Appellant's Exhibit 103

From: Gary Lee
Sent: Thursday, August 08, 2013 4:05 PM
To: Jason Jones
Subject: RE: The Cleveland building

I was in the other week for another project but mentioned this one to you, this is my friends warehouse building at the corner of Cleveland and 164th at:
16390 Cleveland St

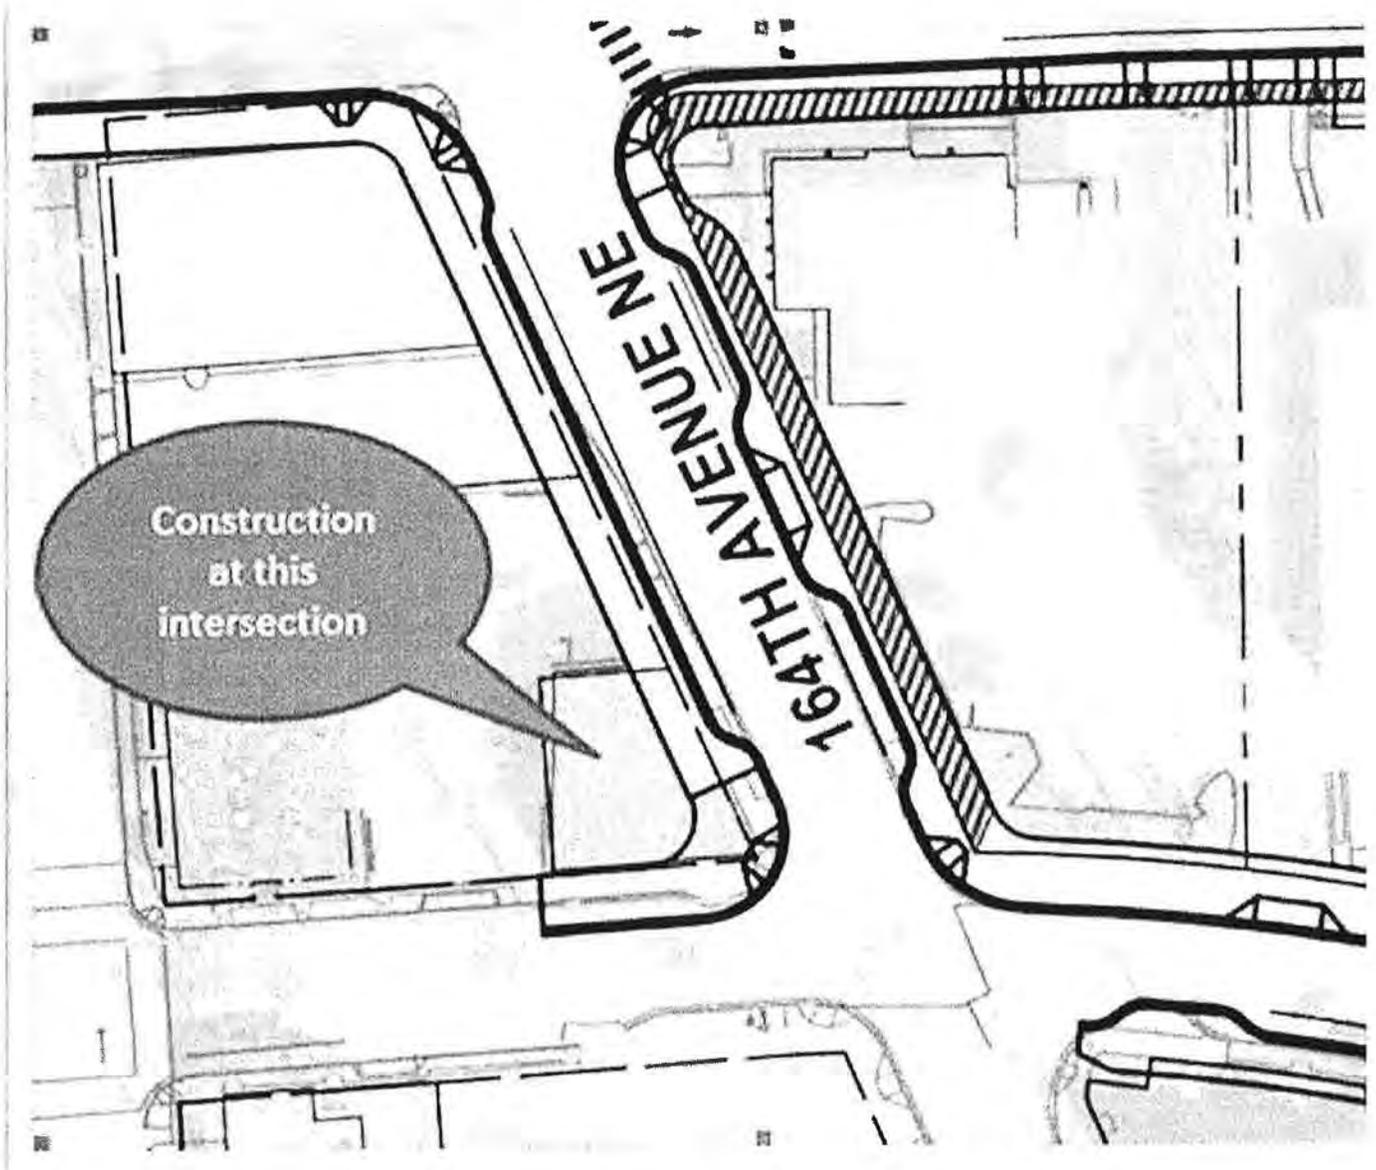
Since the City has an adopted plan for street improvements at this intersection, the modifications to the building would trigger the requirement for full street frontage improvements, similar to what is shown below, thus several feet of the east side of the building would need to be removed and a wider sidewalk (with new curb and gutter) would need to be built with the modification to the building. The trigger for requiring street frontage improvements with building modifications is when the cost of construction/modification equals or exceeds 100% of the existing value of property improvements.
